LAND USE APPLICATION SUMMARY

Property Location: 112 East Hennepin Avenue
Project Name: 116 East Hennepin Redevelopment
Prepared By: Lisa Steiner, Senior City Planner, (612) 673-3950
Applicant: Schafer Richardson
Project Contact: Katie Anthony
Request: To construct a new six-story building attached to two historic buildings.
Required Applications:

BZZ-7573: 112 East Hennepin Avenue

SITE PLAN
C2.0

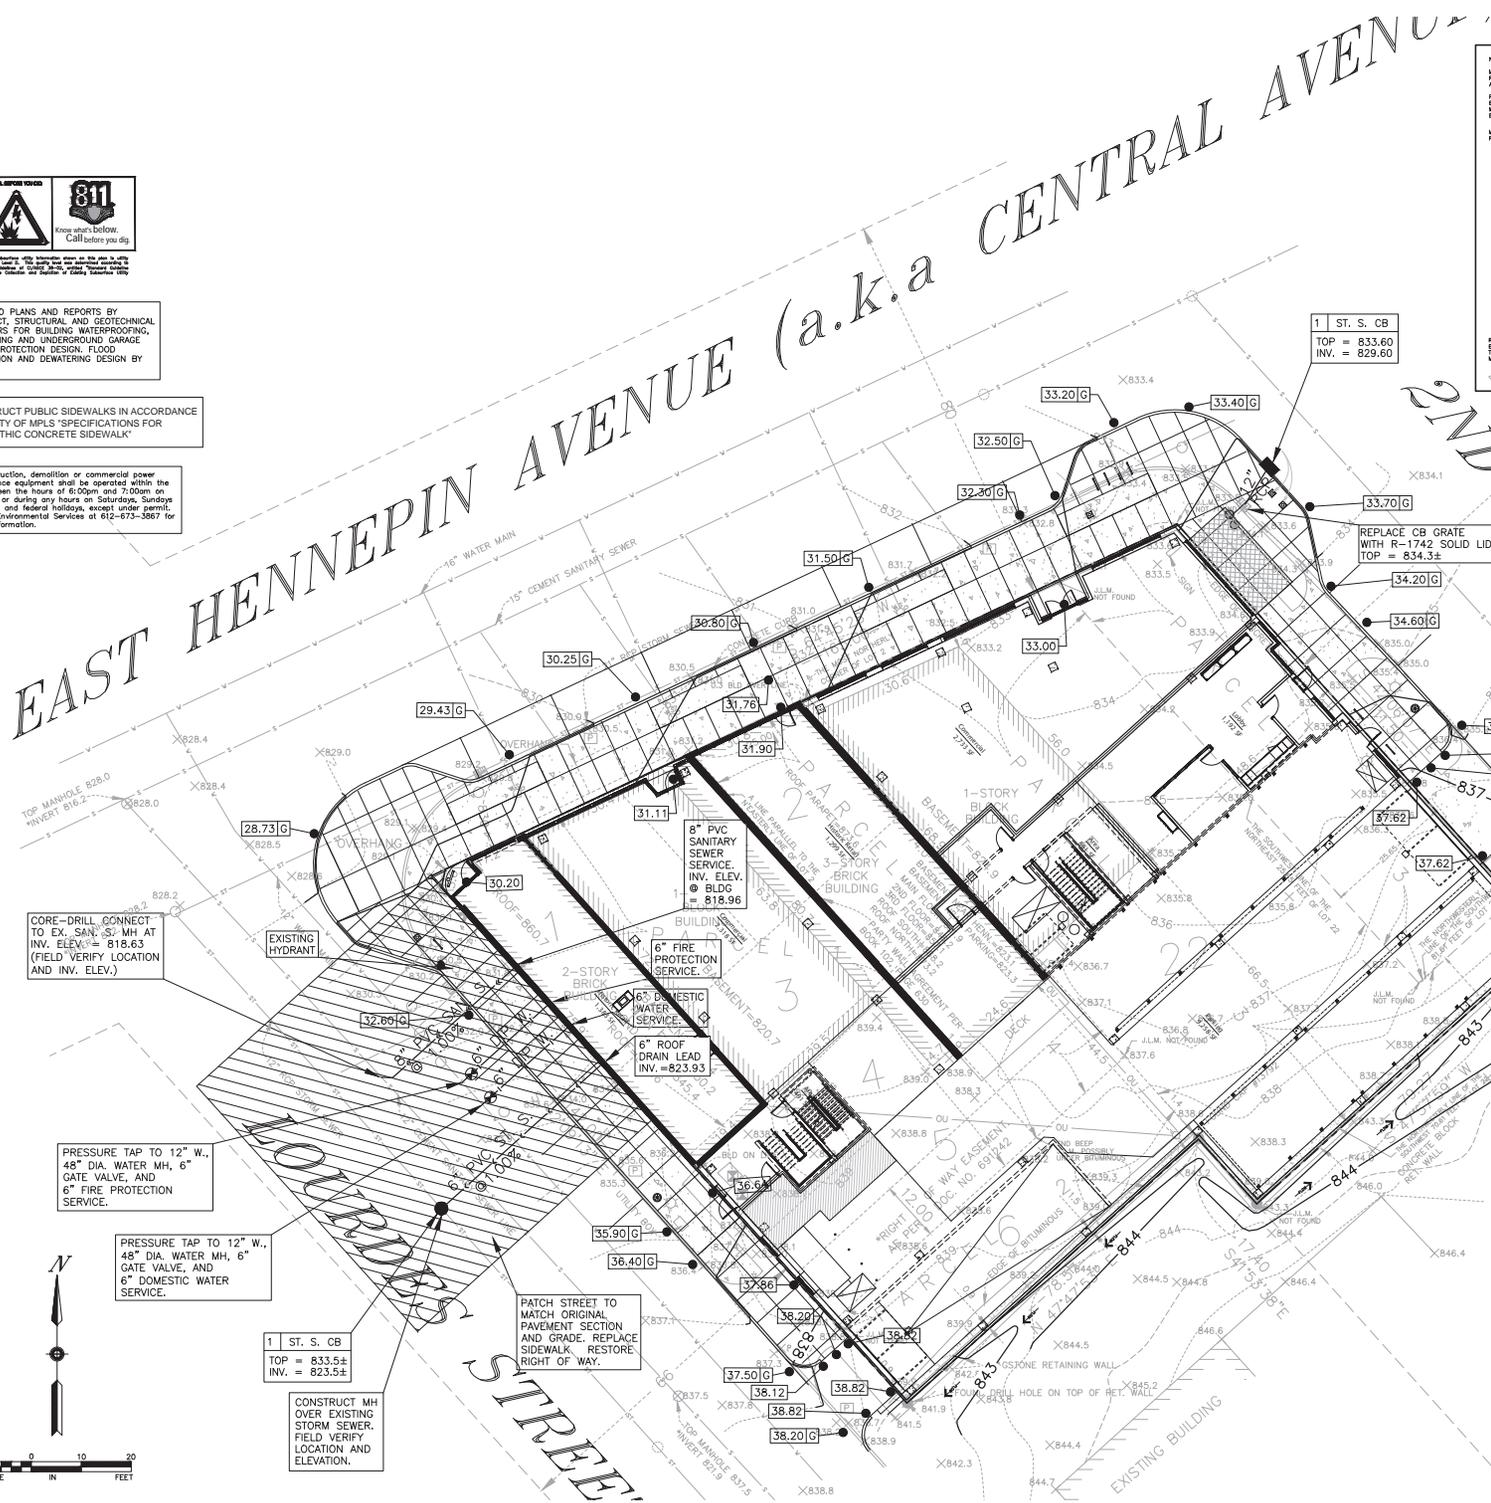
- Note to the Applicant: The site plan proposes curb extensions along Hennepin Ave. that may be in conflict with roadway planning efforts currently underway between Hennepin County and the City of Minneapolis and likely will not be approved. It is recommended that the Applicant meet with the appropriate Public Works Engineering staff regarding impacts to the proposed site plan; please contact Paul Miller at (612) 673-3603 for further information.

- All driveway aprons shall be designed and constructed to City standards. All driveway aprons shall be shown graphically correct on all related plan sheets. Please refer to the following: http://www.minneapolismn.gov/publicworks/plates/public-works_road. The Minneapolis Standard Plate ROAD-2003 provided on Sheet C7.2 has been updated and shall be replaced with ROAD-2003-R1.

- The site plan indicates a location for a proposed electric utility transformer within the Public sidewalk along 2nd St. S.E. however sidewalk ventilation grates are not identified. It is recommended that the Applicant begin discussions with Xcel Energy as soon as possible in order to identify electric utility and transformer locations on the site plan. It should not be assumed that the City will approve any proposed transformer location in the Public right-of-way.

- Please identify the lowest and first floor elevations on the grading plan.
- Please provide details drainage plans for the proposed curb extensions. Based on the current spot elevations, low points will be created that are not served by catch basins.
- It appears grading is proposed on the adjacent property. Approval from that property owner will need to be obtained. Please also verify no runoff from the site is proposed to be directed to that area.

- The proposed storm sewer service connection to the City main should be core-drilled and a saddle tee fitting installed, per City of Minneapolis Standard Supplemental Specifications. A new manhole is not permitted for the connection. Please revise the plans accordingly.

1 LANDSCAPE PLAN
L1.1 SCALE: 1" = 10'-0"

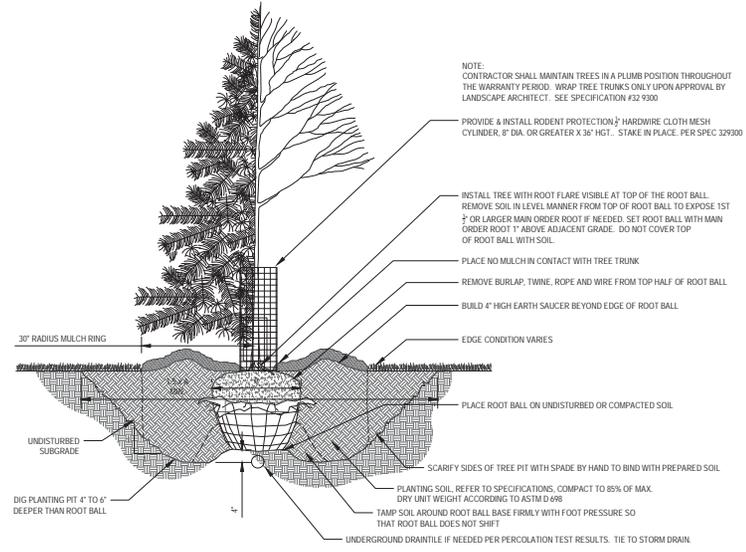
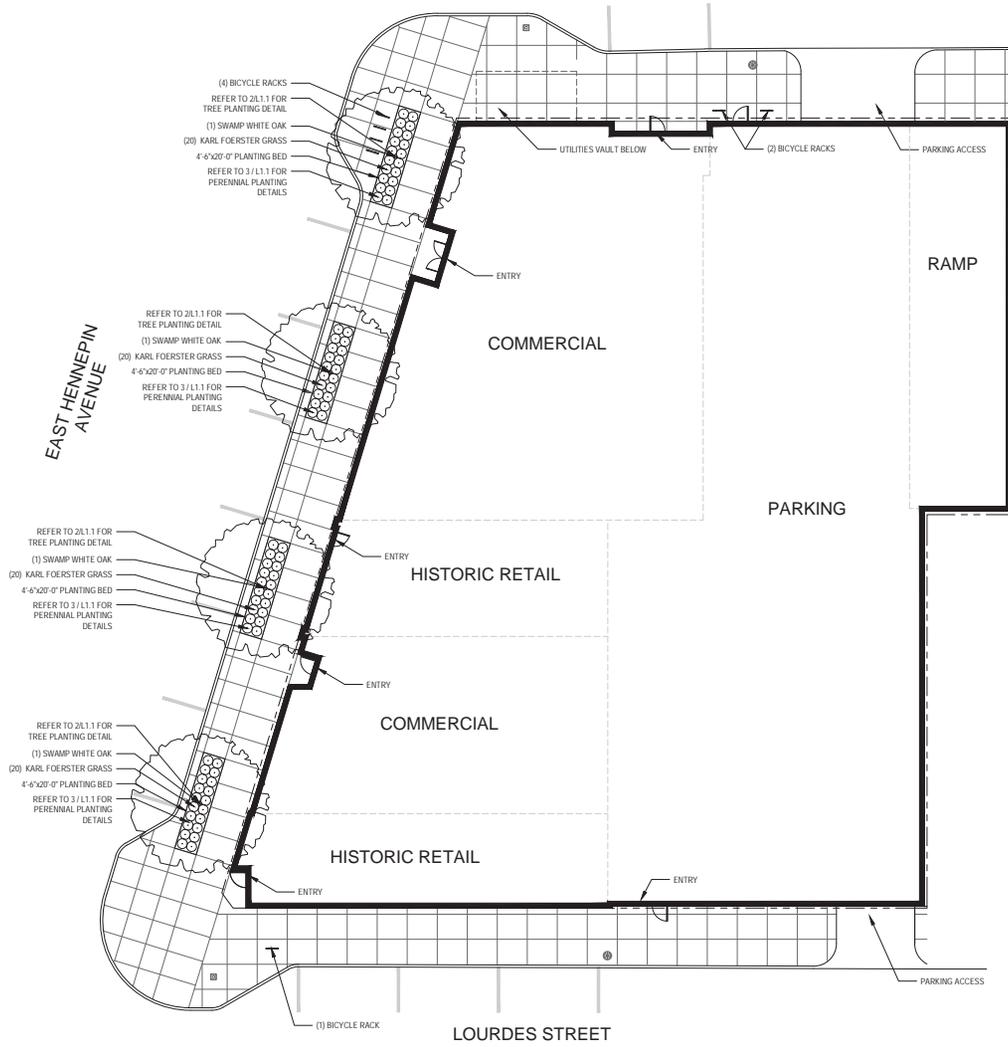
- Oak is overrepresented. Require alternate selection.
- Open planting specaes do not reflect minimum 125sq. Ft./tree.
- Increase to 6' x 20 would be approved (= 120 sq. ft./tree)
